PRODUCT CHANGE NOTIFICATION 0026

Issue Date: 7/7/25

TCI will replace old capacitor parts 27606, 29230, 27607, 3-phase Vishay oil filled type screw terminal capacitors with new capacitor parts 32447, 32449, 32450, 3-phase Vishay oil filled type spring clamp capacitors respectively. The change applies to all designs both standard product and in component kit form. Due to the change in capacitors, capacitor brackets for the 5kVAR and 8kVAR parts will also be updated to accommodate the change. Capacitor brackets for part 32450, 10kVAR capacitor will remain the same.

Figure 2: New Capacitor Mounting Bracket KCAPBKT1D

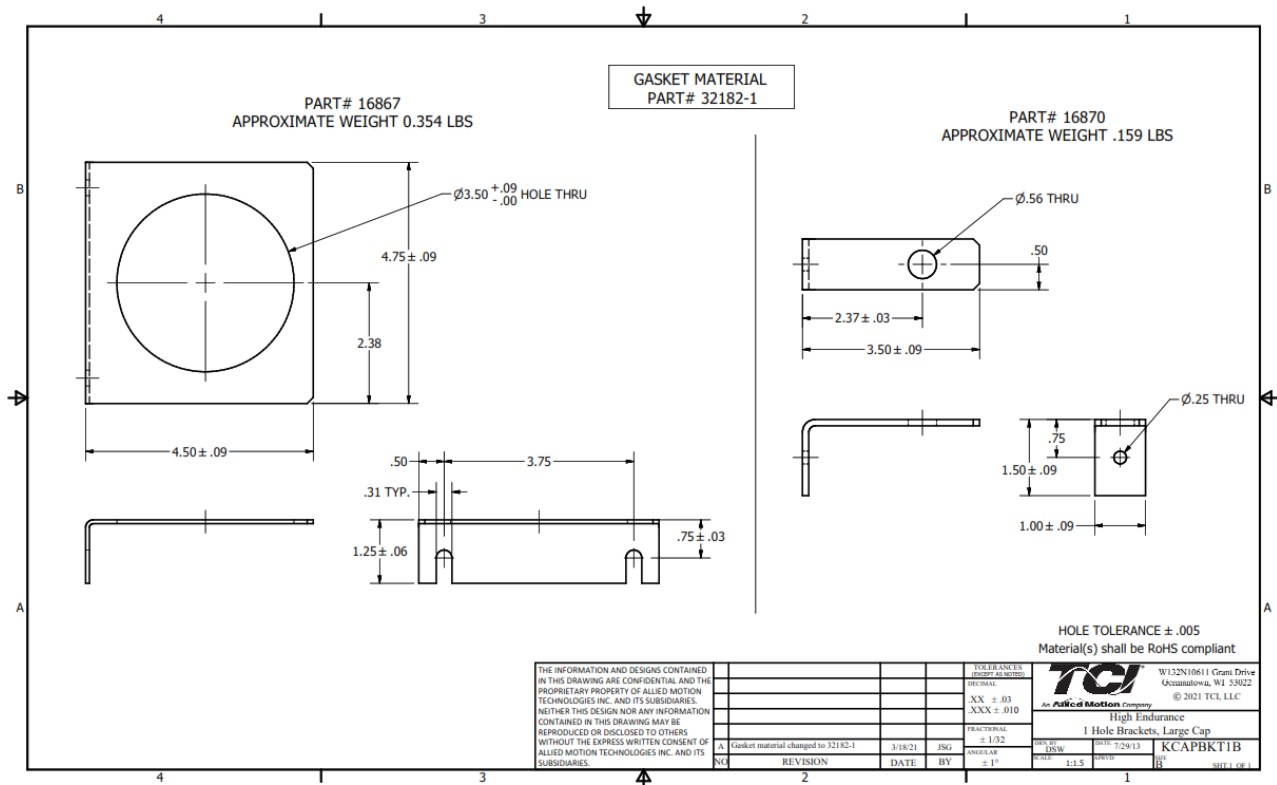
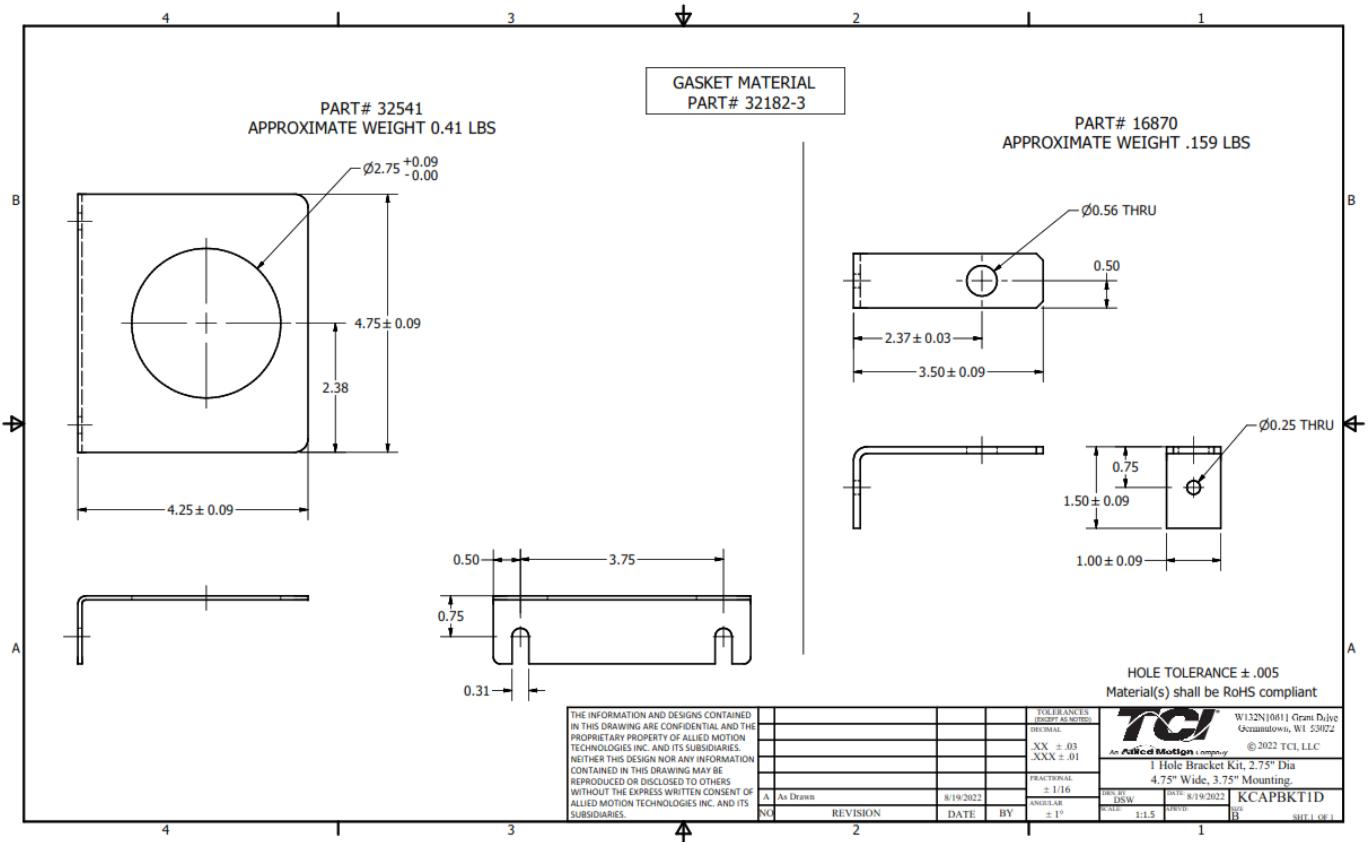
The new capacitor diameter is smaller but the mounting locations/dimensions and hardware are not changing. See below drawing (KCAPBKT1D). Old bracket KCAPBKT1B will transition to KCAPBKT1D.

Figure 4: New 10 kVAR Spring Clamp

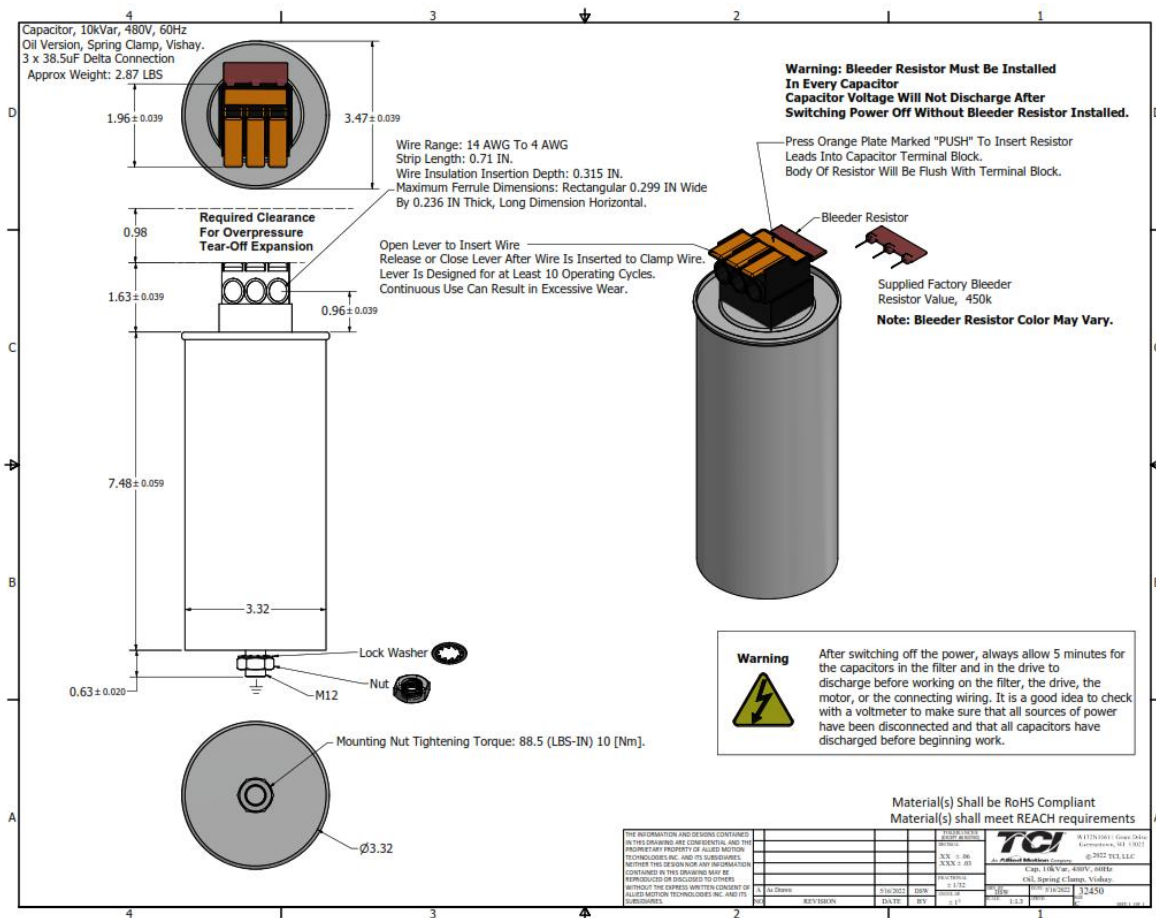
The new Vishay capacitors have a spring clamp terminal block rather than older screw type terminals.

The new capacitor bleeder resistors must be inserted into the capacitor upon inspection.
